NO. 222U-06-74

SUBJECT: ENGINE - GEARBOX - REMOVAL AND REPLACEMENT OF LOCKING CUP PART NO. 4-082-094-01

ENGINE - GEARBOX - Removal and Replacement of Locking Cup Part No. 4-082-094-01

LTS101-72-60-0244

Figure 1. Thrust System - Details of "B" and "C" Gearboxes

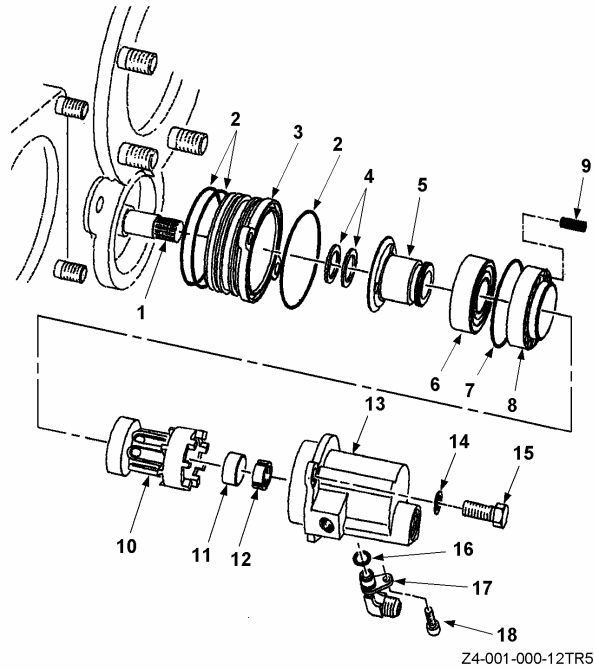
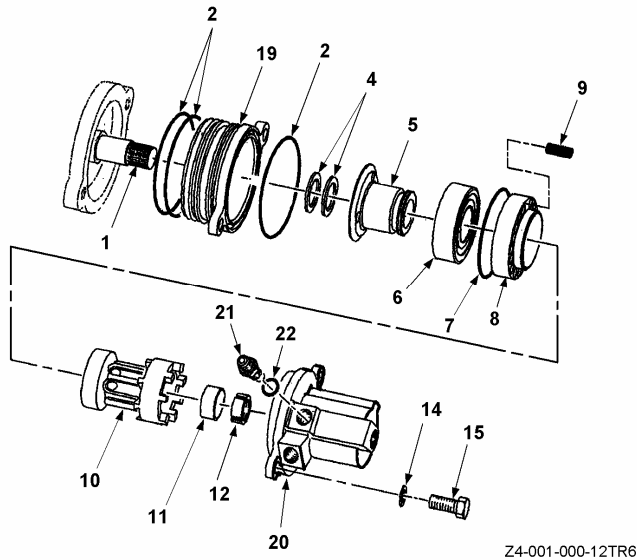
- A. Disassemble the engine to access Locking Cup Part No. 4-082-094-01 (11, Figure 1) and Shim Part Nos. 4-082-088-01 through -10 (4), following the instructions in the applicable manuals listed in paragraph 1.K.

- B. Remove and return Locking Cup Part No. 4-082-094-01 (11) and Shim Part Nos. 4-082-088-01 through -10 (4).
- C. Install Locking Cup Part No. 4-082-094-02 (11) and Shim Part Nos. 4-082-126-01 through -10 (4) as required in accordance with Service Bulletin LTS101-72-50-0174 (revision 5 or later).

- (1) This service bulletin requires removal and replacement of Locking Cup Part No. 4-082-094-01 with Locking Cup Part No. 4-082-094-02 and Shim Part Nos. 4-082-088-01 through -10 with Shim Part Nos. 4-082-126-01 through -10 as required by correct engine build clearance of Py probe.
- (2) This service bulletin also requires using updated assembly procedures in Service Bulletin LTS101-72-50-0174 (revision 5 or later).
